An Analysis of Hydrogen Control Measures
at McGuire Nuclear Station
Revision 8

Insertion Instructions
Volume 3

Duke Power Company Response to Proposed
Enhancements to the McGuire Hydrogen Mitigation System
Transmitted by Letter from Ms. E. G. Adensam, Dated March 16, 1983

Figure 3.4-3
McGuire Containment - Section at EL 738

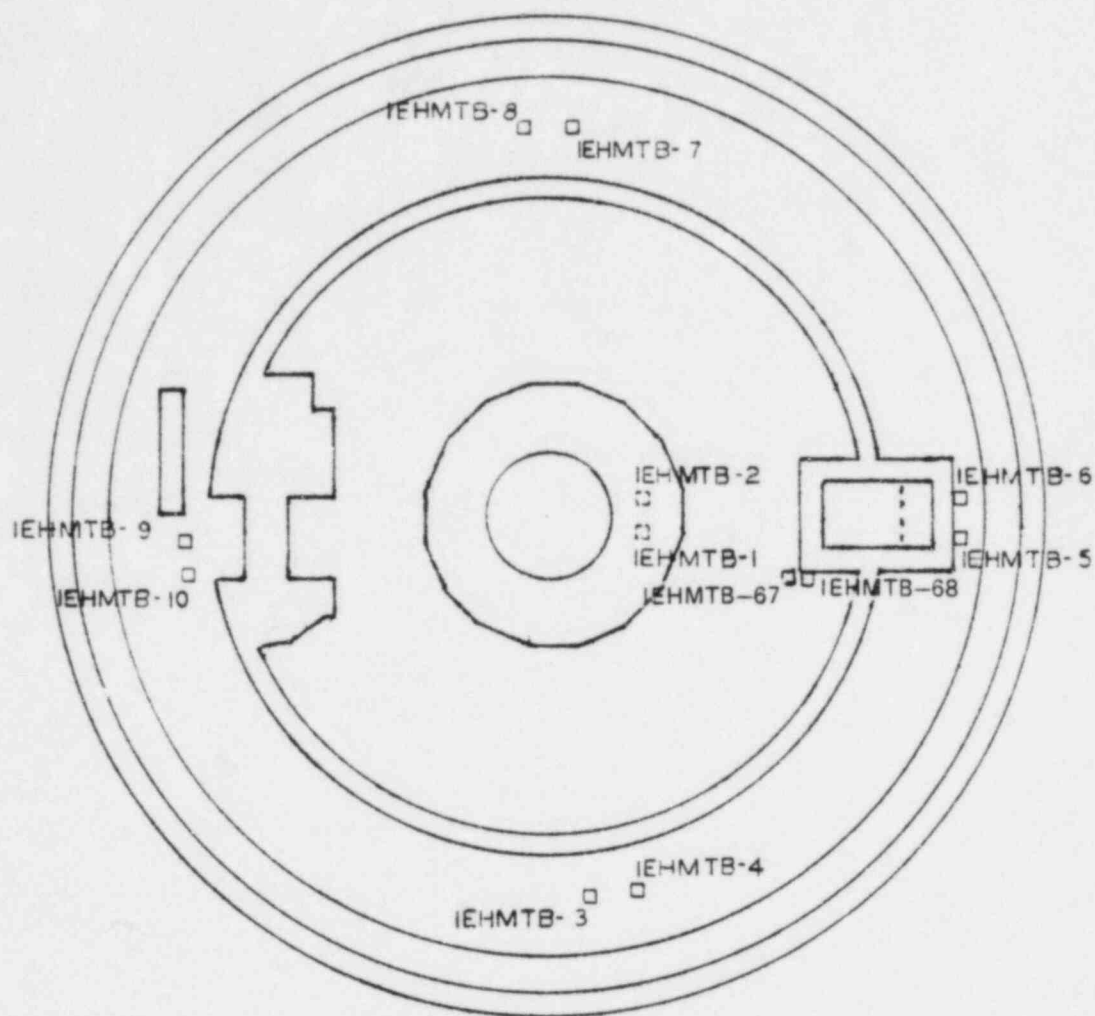
Based on the previous discussion, it may be concluded that location of the upper compartment igniters is not an important consideration in design of the Hydrogen Mitigation System. The present locations have been shown to be adequate, and better performance from alternative locations has been shown to be unlikely. However, to resolve the issue with the NRC Staff, four igniters will be added at a lower elevation in the upper containment. This location will be at approximately elevation 824' in the vicinity of an existing platform on top of the steam generator enclosures. At the top of the steam generator enclosures are concrete wing-like structures upon which the missile shields are placed during refueling. These concrete structures extend toward the centerline of the containment building from the crane wall and will therefore permit mounting the hydrogen igniters close to the compartment centerline. One igniter will be located on each of the four outboard concrete structures. The exact locations will be determined on the basis of providing access to the igniters for maintenance and testing but keeping them out of the way of the missile shield handling area. The new igniters will be placed so that one redundant pair is on each side of the containment, with the igniters located approximately 80° apart. These igniters will be powered from two new circuits from the emergency lighting system.

FIGURE 3.4-5

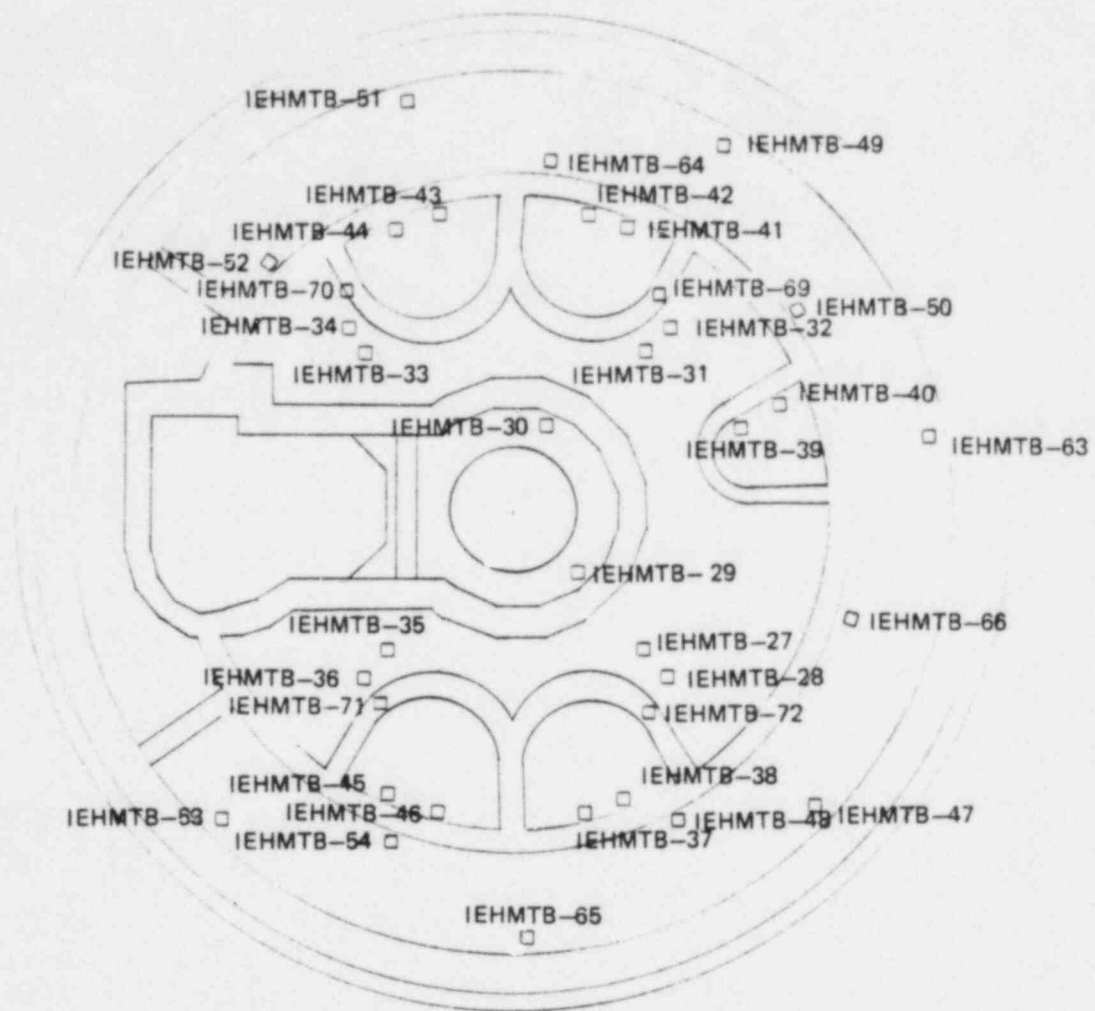
As presented in the general discussion section previously, we do not rely on global burns at higher concentrations to protect the containment. In our CLASIX analysis, we forced the containment response to be based on global burning to represent the worst case in terms of containment pressure and temperature response. We expect that our arrangement of igniters will result in a very large number of much smaller burns, initiated at concentrations of 5-7% in the vicinity of the igniters and propagated in all directions by the turbulent actions of the fan and jet mixing occurring in the lower containment. A substantial amount of the available hydrogen will be consumed in this manner because of the long period of time that these hydrogen concentrations will be available in the vicinity of the igniter and the available turbulent mixing which effectively refreshes the ignitable mixture in the vicinity of the igniters while promoting global propagation. Accordingly, no beneficial effect can be attributed to the addition of igniters at lower elevations in the lower compartment. However, to resolve this issue with the NRC Staff, two additional igniters will be added in the lower containment compartment. These two new igniters will be located at approximately elevation 730' in containment and outboard of the pressurizer relief tank. The exact location will have to be determined in the field and may vary slightly between units, depending on the available space. This elevation is below the midplane of the pressurizer relief tank and about five feet from the containment floor. Because these two igniters are below the post-LOCA flood level in containment, they will be wired to existing circuits which contain igniters below the post-LOCA flood level.
